EUROCOPTER
DIRECTION TECHNIQUE SUPPORT
13725 MARIGNANE CEDEX FRANCE

ALERT SERVICE BULLETIN

No. 55.00.12**SUBJECT: STABILIZER(S)**

Improvement of attachment strength for upper and lower fin skids

Figure 1

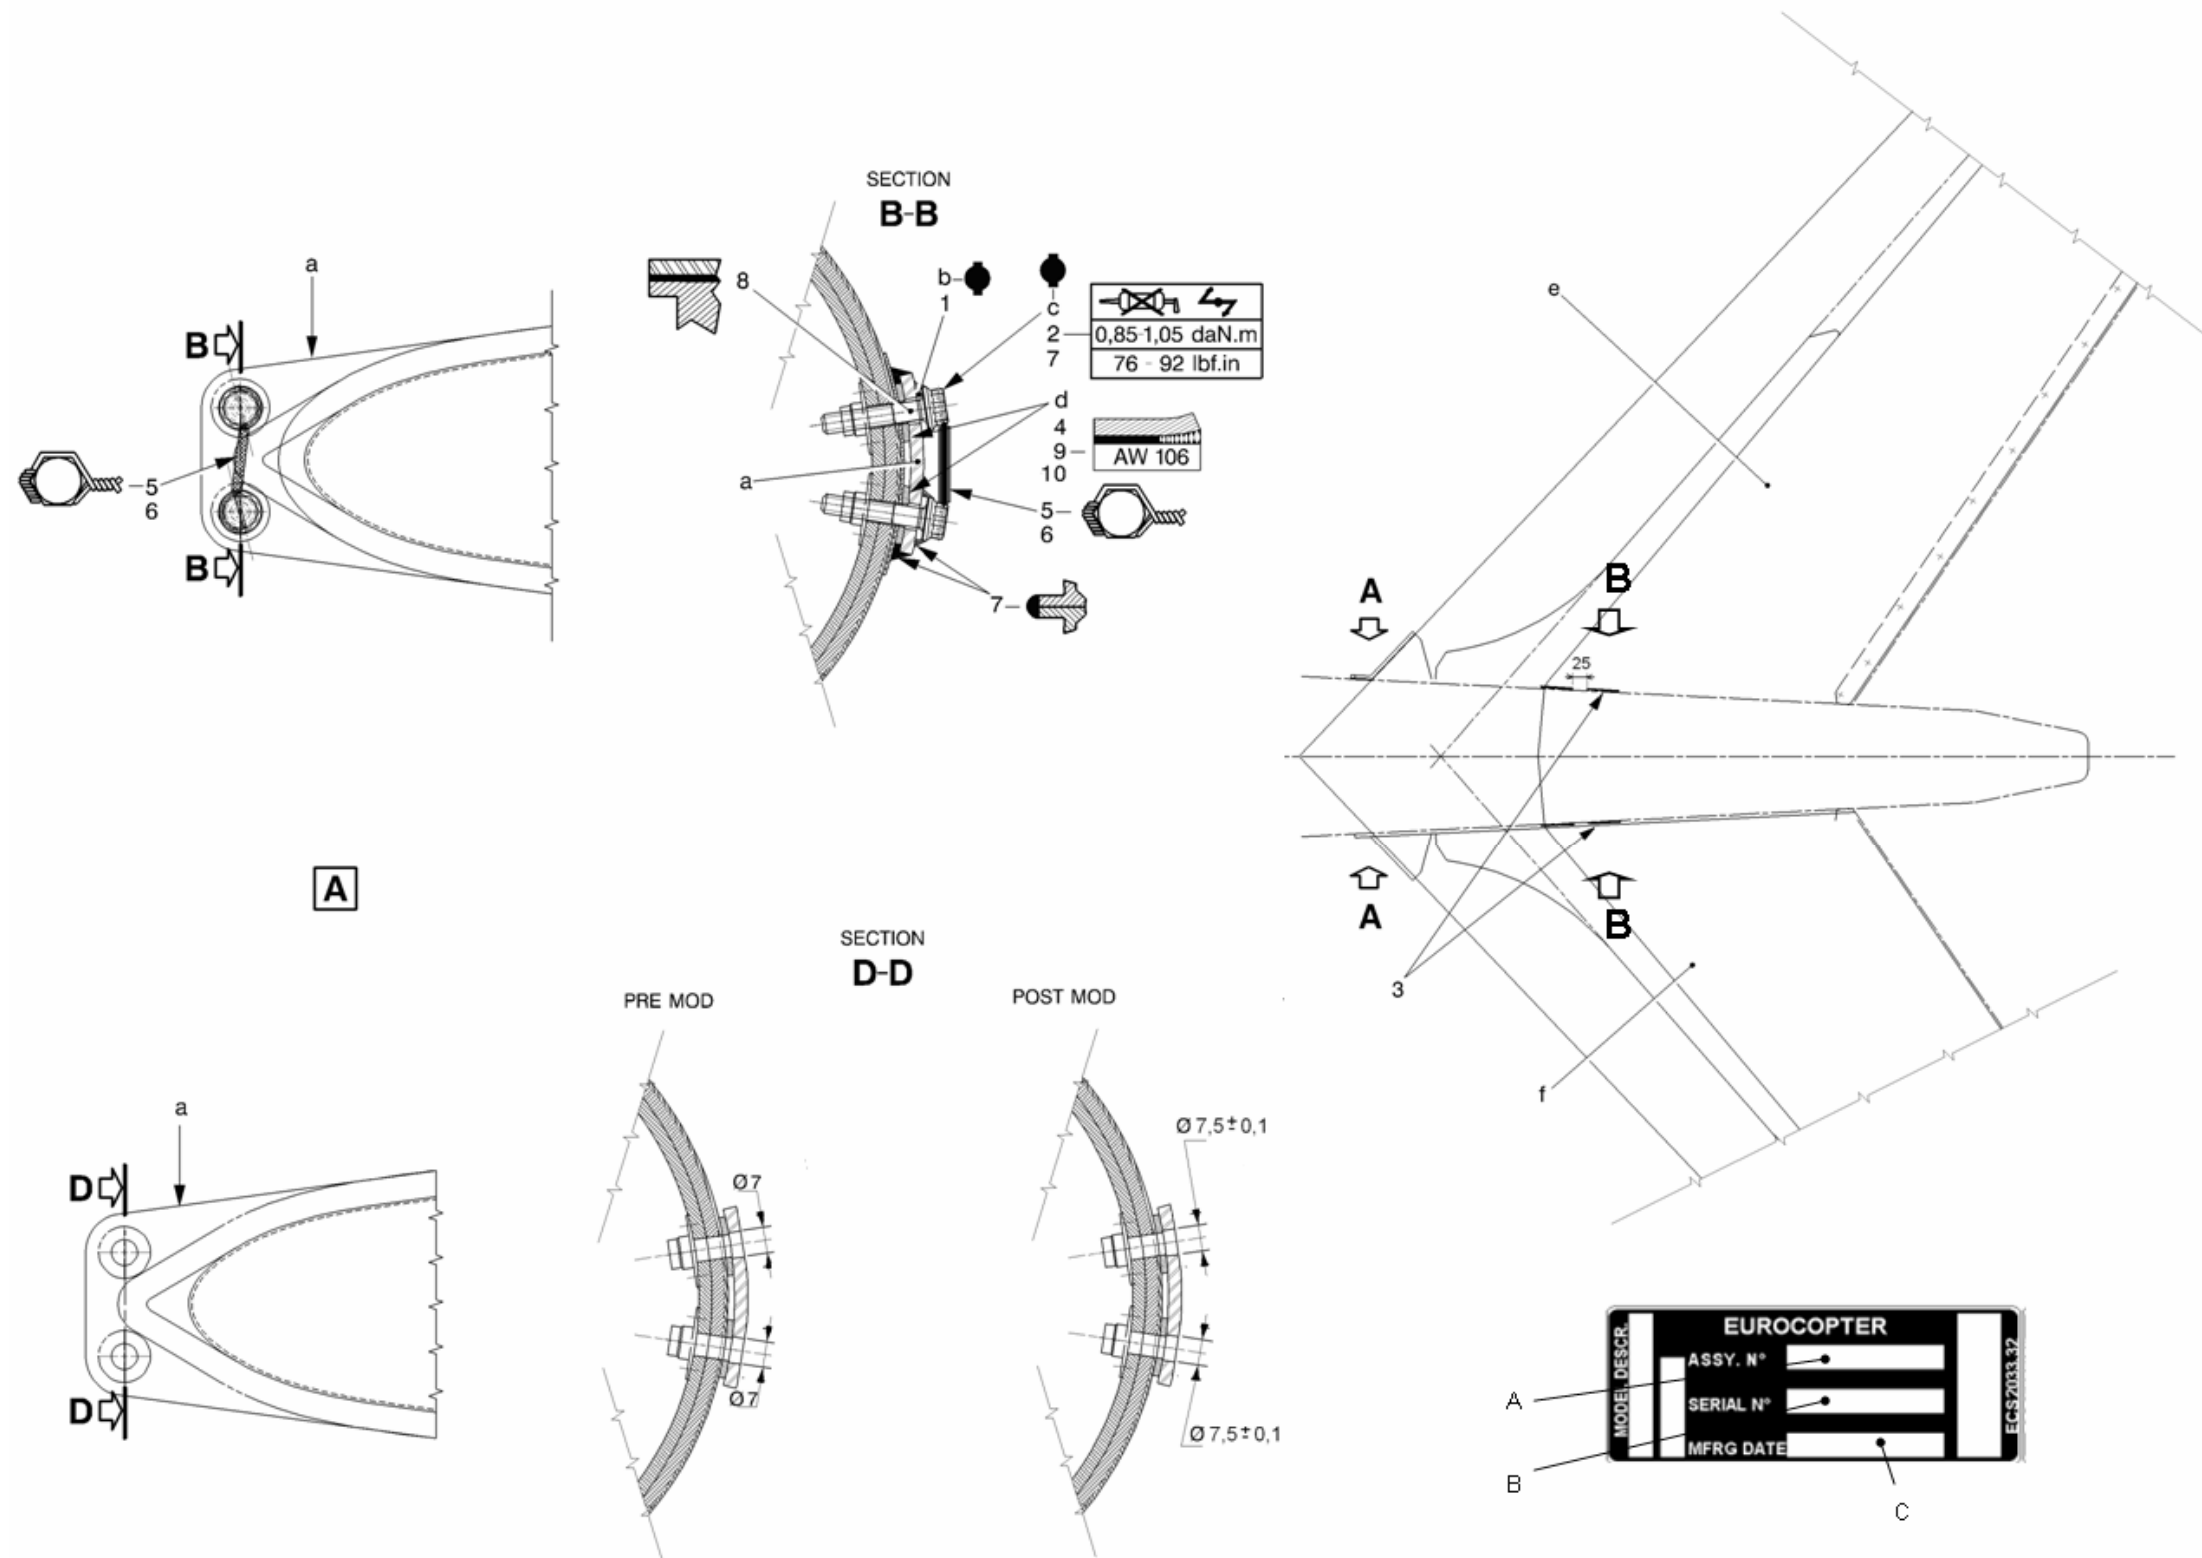
- reducing risks of loaded installation by increasing the diameter of passage holes for bolts on lower and upper fin attachment fittings on tail boom.
- improving fatigue strength of upper and lower fin attachment by replacing bolts P/N: 22126BV060032L with special bolts with higher head P/N: 350A23-4016-20 and replacing washers P/N: 23112AG060LE with special washers P/N: 350A23-4017-22.

- Remove and separate upper fin (e) from lower fin (f) as per Work Card 55.00.00.402 (MET).
- Scrap bolts (c) and washers (b).

2.B.2.b. Modification of lower and upper fittings on work bench (Figure1, Detail A and Section D-D)

- Increase initial diameter of passage holes for bolts in fitting (a) from 7 mm to 7.5 mm + or – 0.1 mm.
- Deburr and carry out protection against corrosion.
- Carry out paint touch up, as required, as per Work Card 20.04.05.101 (MTC).

2.B.2.c. Installation of fins (Figure 1, Detail A and Section B-B)

- Assemble upper fin (e) and lower fin (f) as per Work Card 55.00.00.402 (MET).
- Offer up fin assembly on tail boom.
- Check presence of peel washers (d) installed underneath fitting (a):
 - If peel washers are present (d), check that fitting (a) is properly resting on existing washers (d). Otherwise, remove peel washers (d) and carry out procedure below,

- define thickness of peel washers (4) to be installed as per clearance read,
 - install and bond peel washers (4) on skin of tail boom by means of adhesive (9) and hardener (10) as per Work Card 20.06.02.303 (MTC).

- Loosen TGB attachment bolts TGB in order to facilitate installation of new bolts (2).
- Coat shank of bolts (2) with sealant (8).
- Fit bolts (2) fitted with washer (1).

- Tighten bolts (2) to torque.
- Safety bolts (2) by means of lockwire (5).
- Protect twist of lockwire (5) with a piece of sheath (6).
- apply bead of sealant (7) on periphery of fitting (a) of fin (e or f) and around heads of bolts (2).
